Well Name: RAE'S CREEK 25 36 22 FED COM	Well Location: T25S / R36E / SEC 22 / SWSE / 32.1091419 / -103.2501764	County or Parish/State: LEA / NM
Well Number: 095H	Type of Well: OIL WELL	Allottee or Tribe Name:
Lease Number: NMNM136231	Unit or CA Name:	Unit or CA Number:
US Well Number:	Operator: MATADOR PRODUCTION COMPANY

Sundry ID: 2865125

Type of Action: APD Change

Procedure Description: Matador request the option to amend the well design of the Raes Creek 25 36 22 Fed Com 095H and make the following changes to the current APD: - BHL will be moved from 110' FNL and 1651' FEL to 110' FNL and 333' FEL. Updated C102 attached. - Change the well target from 10700' to 14330' TVD - Add a 8.75" pilot hole to 14772' TVD - Modify casing and hole as shown on the casing and cement table

Pilot Hole Program

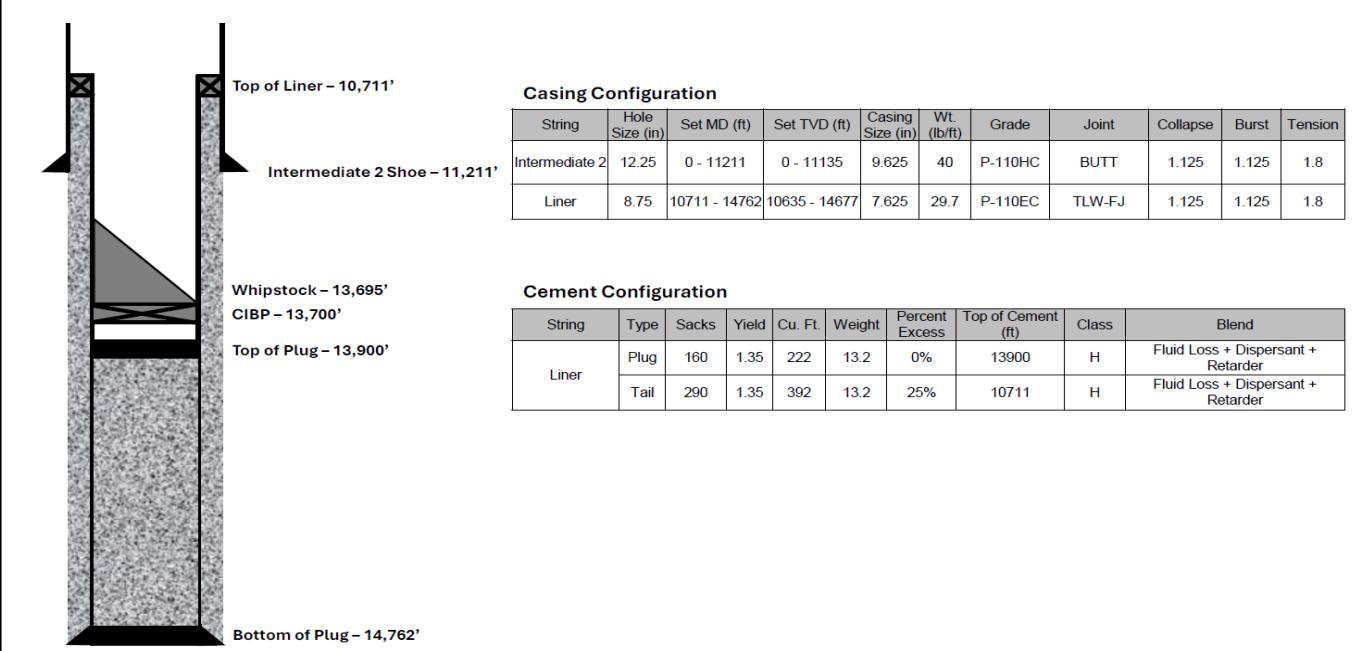
The 8.75" pilot hole will be drilled to ~14,772' MD and then cased and cemented. A cement plug will be put in place inside the liner from ~14,762' to ~13,900', then a cased hole whipstock will be set at ~13,700' MD to mill a window in the casing for the 6.75" production section.

The pilot hole plugging procedure is approved as written, with the modification that more cement will be needed to have the inside plug from 14,762 ft. to 13,900 ft. Please adjust the cement volume accordingly. Note plug tops on subsequent drilling report. The BLM is to be contacted 24 hours prior to the commencement of any plugging operations (575-689-5981 Lea County) and when tagging the plugs.
